SCALE	
LONGITUDINAL, 1cm = 12m	PANEL SIGNALLING PLAN 'B' CLASS STD-III
TRANSVERSE, 1cm = 4.8m

PARSABAZAR
परसाबाजार

DRAWING NO. ~~RE/DNR/SI-1/02~~ ECR/SIP/DNR/288/2011

ALT.	DESCRIPTION	REFRENCE	CHECKED			APPROVED	CRS SANC/COMP.
⊗	PROVISION OF INTERLOCKED SLIDING BOOM IN ADDITION TO EXISTING LIFTING BARRIER AT LC GATE NO: 7C'	SR.DSTE/DNR, L.NO: SG/DRG/DNR, DT: 09/09/2020	SSE/S	ASTE/D&D	DY.CSTE/D&D	(RISHI GUPTA) PCSTE/ECR/HJP 28.10.20	CRS SANC IN LBT

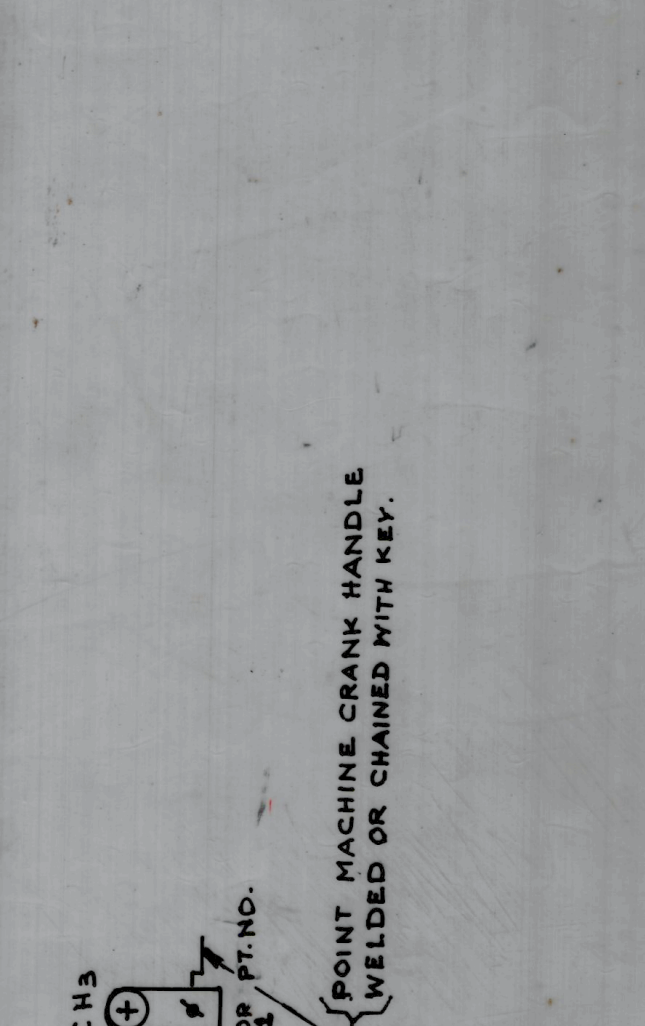
13. UFSBI BLOCK PANEL WITH BPAC (HASSDAC) PROVIDED BETWEEN PARSABAZAR - PATNA JN.
14. ELECTRIC LIFTING BARRIER PROVIDED AT L.C GATE NO. 7 'C'.
15. SLIDING BOOM PROVIDED AT LC GATE NO: 7C'

16. ROAD SIG. SHALL DISPLAY RED ASPECT AT LC GATE NO: 7C' WHEN SLIDING BOOM IS USED TO CLOSE THE ROAD TRAFFIC.

EKT-'A'	CONTROLLED BY G-15 EKT 'B'	EMERGENCY KEY	ELB GATE PANEL	SLIDING KEY 'R1'
KEY 'B' TO COME OUT FROM EKT 'A' AFTER BOOM LOCKING AND CLOSING THE DETECTION CONTACTS.	KEY 'B' TO COME FROM EKT 'A' OR SLIDING BOOM	(NON LOCK TYPE) ARMATURE REMOVED (SEALED)	GATE OPEN ~~SWITCH~~ BUTTON / GATE CLOSE ~~SWITCH~~ BUTTON / GATE COMMON EMERGENCY BUTTON	(NON LOCK TYPE) ARMATURE REMOVED (SEALED)
